PCN-20190109 TE0808-04-* SPI Flash Change

Company	Trenz Electronic GmbH
PCN Number	PCN-20190109
Title	TE0808-04-* SPI Flash Change
Subject	BOM change
Issue Date	2019-07-15

Locate Flash (U7, U17) on bottom side of PCB:

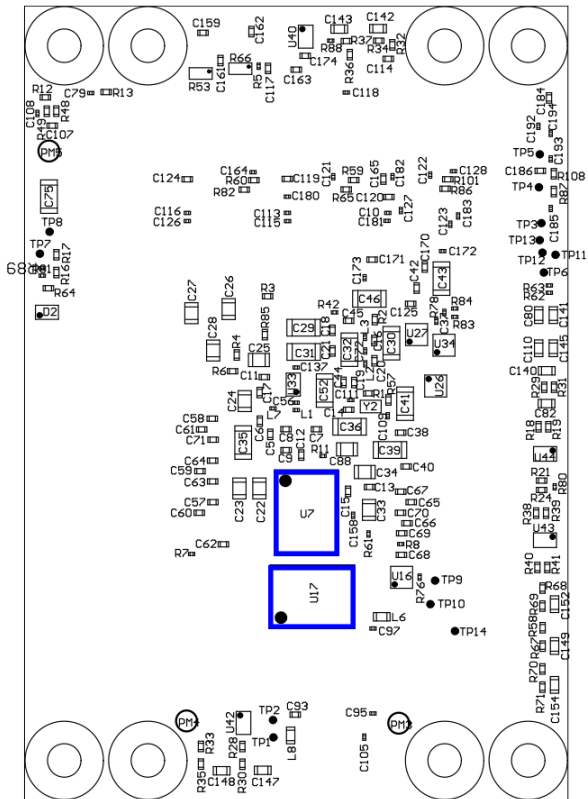
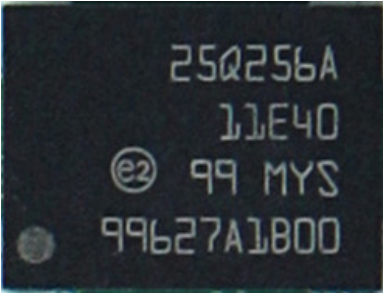
#1 Change SPI Flash from N25Q512A11G1240E to MT25QU512ABB8E12-0SIT

Reason: N25Q512A11G1240E became obsolete.

Impact: None. Both have same JEDEC ID BB20h and manufacturer ID 20h.

old	new
N25Q512A11G1240E	MT25QU512ABB8E12-0SIT
